**Economic Commission for Europe****Inland Transport Committee****World Forum for Harmonization of Vehicle Regulations****Working Party on Lighting and Light-Signalling****Eighty-third session**

**UN Regulation No. 48 (Installation of lighting and light-signalling devices):****Proposals for new series of amendments to UN Regulation No. 48****Revised proposal for a new [0x] series of amendments to UN Regulation No. 48****Submitted by the Informal Working Group on Simplification of Lighting and Light-Signalling Regulations\***

6.2.6.1.2. **Vertical inclination limits of the cut-off**

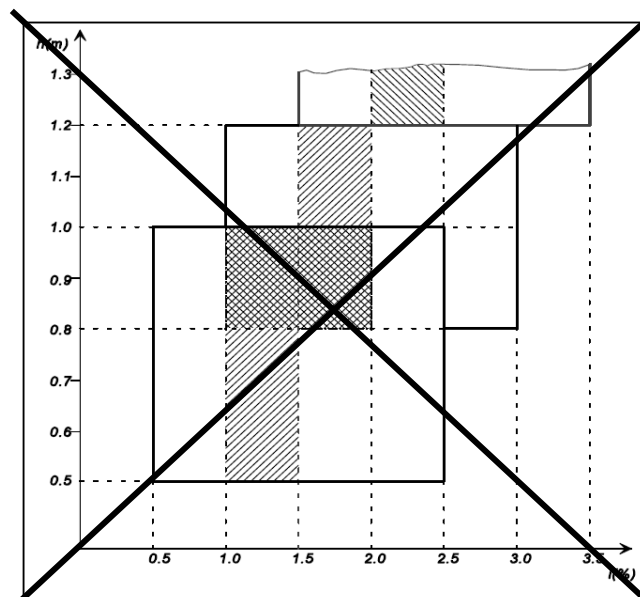
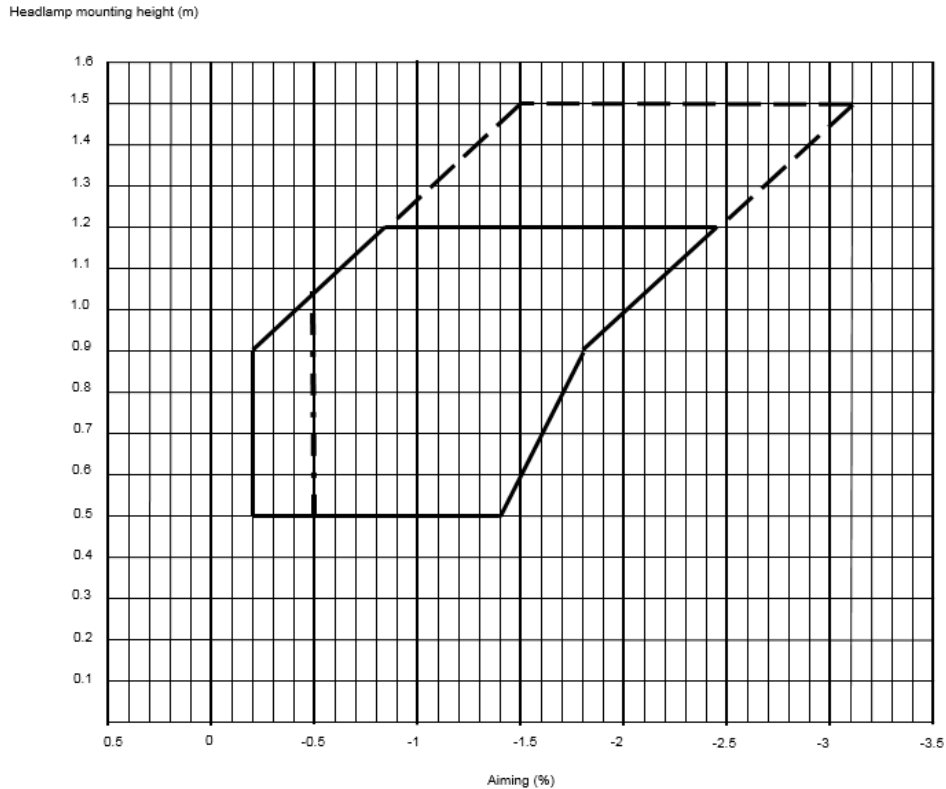
Depending on the mounting height in meters (h) of the lower edge of the apparent surface in the direction of the reference axis of the **passing beam (dipped-beam) headlamp**, measured on the unladen vehicles, the vertical inclination of the cut-off of the **passing beam (dipped-beam)**, **starting from the initial downward inclination value set by the vehicle manufacturer as prescribed in paragraph 6.2.6.1.1.**, shall under all the static conditions of Annex 5, remain between the following limits and the initial aiming shall have the following values: **under all the static loading conditions of Annex 5:**

<i>Mounting height h [m]</i>	<i>Upper inclination limit [per cent]</i>	<i>Lower inclination limit [per cent]</i>
<b><math>0.5 \leq h \leq 0.9</math></b>	<b>-0.20</b>	<b>-1.40 to -1.80*</b>
<b><math>0.9 &lt; h \leq 1.2</math></b>	<b>-0.20 to -0.85*</b>	<b>-1.80 to -2.45*</b>
<b><math>1.2 &lt; h \leq 1.5^{**}</math></b>	<b>-0.85 to -1.50*</b>	<b>-2.45 to -3.10*</b>

\* increasing linearly, in relation to the dipped beam headlamp mounting height

\*\* for categories N<sub>2</sub>G and N<sub>3</sub>G (off-road) vehicles only

The above limits and the initial aiming values are summarized in the diagram below.

14. Paragraph 6.2.6.1.2. describes the new requirements for the vertical inclination limits of the cut-off, the provisions of which have been reorganised to improve readability. The vertical inclination values according to the installation height are presented in a table. A new diagram has been inserted providing an illustration of the requirements (aiming in per cent on the horizontal axis and headlamp mounting height in meters on the vertical axis).

15. Explanations of the lines in the diagram are given below.

16. The vertical line on the left was initially defined at 0 per cent and derived from the GTB study based on the ‘Klettwitz study’ (informal document GRE-71-32). However, some Contracting Parties were reluctant to have the horizontal cut-off with no downward inclination. At its seventy-eighth session, GRE experts decided to keep the previous vertical limit of - 0.2 per cent.

17. The inclined line on the left (starting from 0.9 m\* in height), results from a mathematical calculation based on the position of the oncoming driver's eyes (at 0.94 m high) for headlamps up to a height of 1.2 m, measured at a distance of 25 m and with an initial aim of 1 per cent down. Using this calculation, it is possible to increase the inclination proportionally to the installation height and still guarantee that glare remains under control; the cut-off line will always stay under 0.94 m at 25 m distance (informal document VGL-10-03, sheet 13).

18. In addition, the line on the left side of the diagram was extended from a height of 1.2 m to 1.5 m in spite of the fact that, during the Klettwitz tests, no vehicles of categories M<sub>2</sub>/M<sub>3</sub>/N<sub>2</sub>/N<sub>3</sub> were tested. This is the reason the lines above a height of 1.2 m are shown as dotted lines.

19. To cover all possible cases of a same type of vehicle (aiming tolerances / chassis deviation / cut-off-line stability / tyre deviation / full or empty tank / levelling device), a range of 1.6 per cent was agreed (see a survey of the International Organization of Motor Vehicle Manufacturers (OICA), informal document VGL-10-10) and used to define the right hand limit and the point (-1.8 / 0.9), based on line defined in item 16.

20. Starting from 0.9 m high, the range of 1.6 per cent is applied to define the line on the right side of the diagram and up to 1.5m.

21. On the right side, under 0.9 m high, there was a compromise to reduce the range progressively to 1.4 per cent at a height of 0.5 m (ECE/TRANS/WP.29/GRE/81, para. 10 and Annex II).

22. The vertical dotted line at -0.5 per cent is already explained in item 10 to address the PTI concerns.

Annex 2, amend to read:

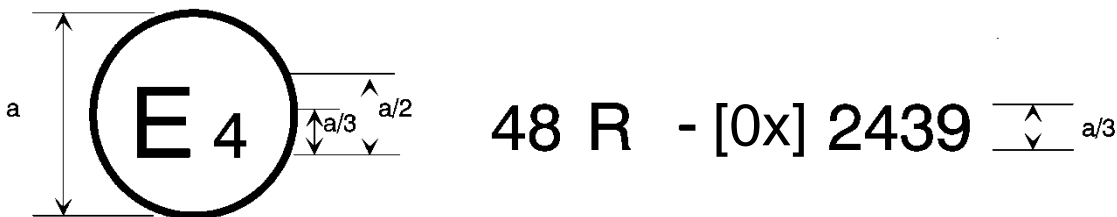
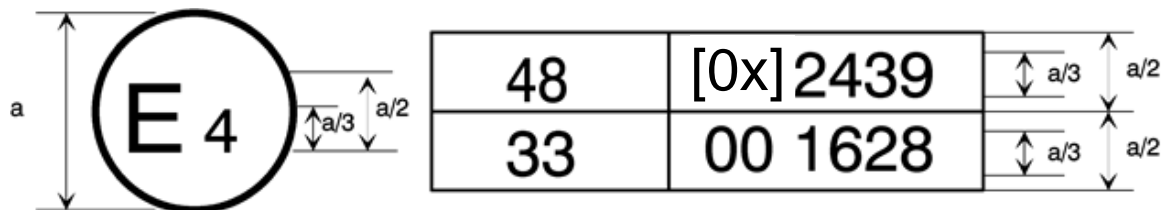
29. Some editorial corrections are made to Annex 2 (Arrangements of approval marks)

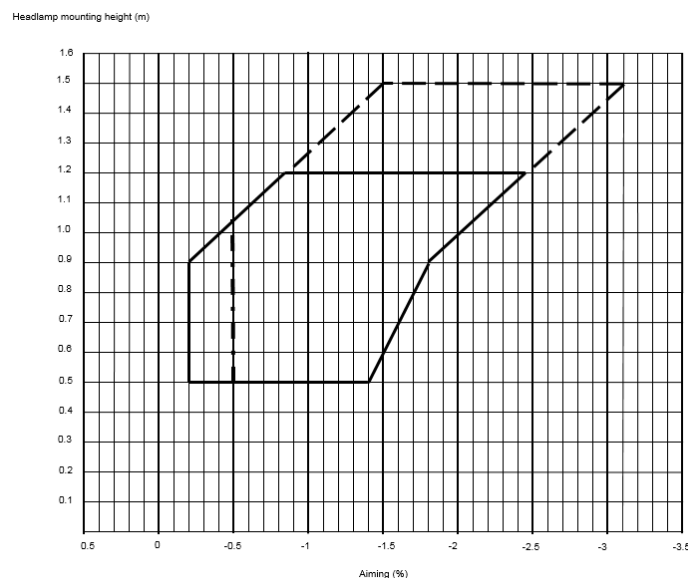
10. Paragraph 6.2.6.1.1., which provides the requirements for initial downward inclination, has been rearranged to improve readability. An additional requirement is introduced to limit the initial downward vertical inclination to the value of -0.5 per cent or less. The goal is to take into account the tolerances which have to be considered during the Periodical Technical Inspection (PTI) of headlamps. This topic was addressed during the IWG SLR Ad-hoc meeting on “Headlamp levelling”, held in Bonn on 28 November 2019 (the meeting minutes can be found in informal document Ad-hoc 04-Rev.1, based on presentation Ad-hoc 03).
